# FTI-NSP2 Type 2 - Vehicle Coverage & Preparation Notes

# FTI-NSP2 Harness Bulletin - Mis-wired POC1 (parking lights)

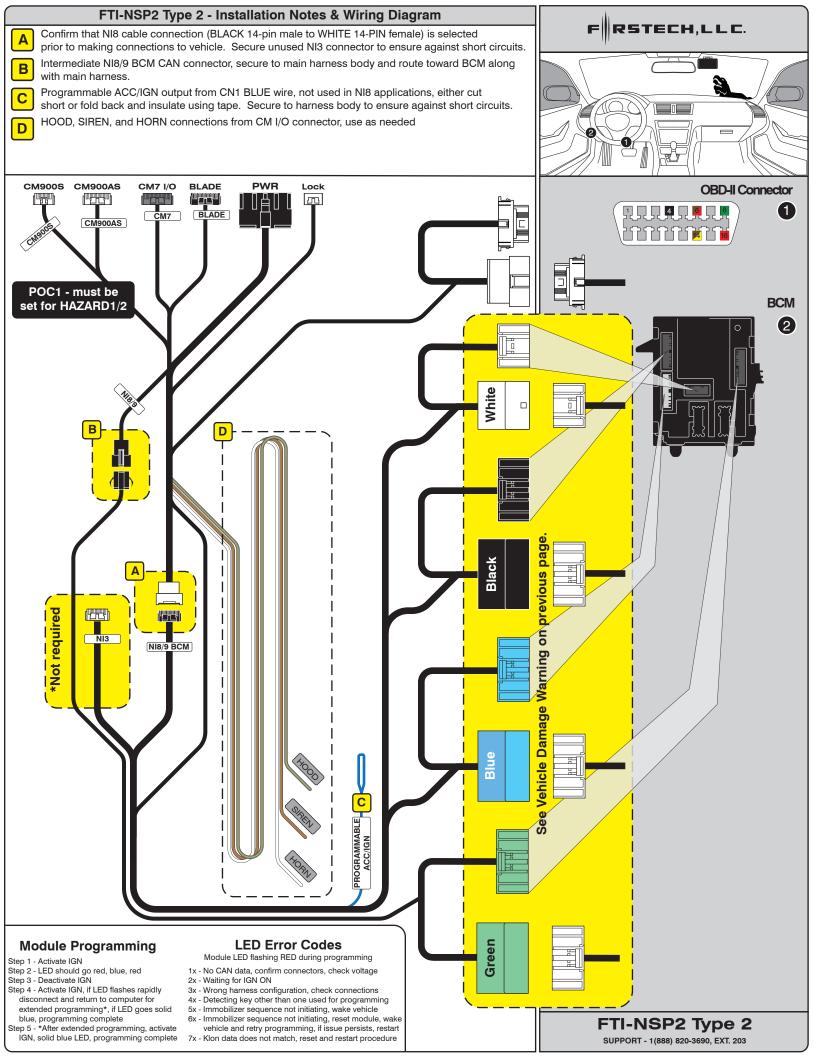
Overview: The initial production release of the FTI-NSP2 harness has an issue where the POC1 circuit is incorrectly positioned in the CM7 I/O connector. This issue affects only the gray 20-pin CM7 I/O connector illustrated below in figure 1.

Issue: The green/white parking light circuit is positioned in pin position #17, the fixed light output where the green/white wire is typically placed for parking lights, but the harness solution uses the vehicle hazard lights instead, the result when used as supplied is an erratic light display.

- 1.) Use a pick tool to depress the locking tab on the terminal connector of the green/white wire
- 2.) Remove wire and prepare to reposition
- 3.) Once removed, reposition the locking tab by using a razor knife to lift the tab into a usable position
- 4.) With locking tab repositioned, relocate to pin position #1 (top right position as illustrated)
- 5.) Push the terminal connector into the I/O connector housing until the locking tab clicks into place and the wire is secure
- 6.) Correction complete, you may now complete the installation, but remember to configure POC1 for Hazards (setting #30)
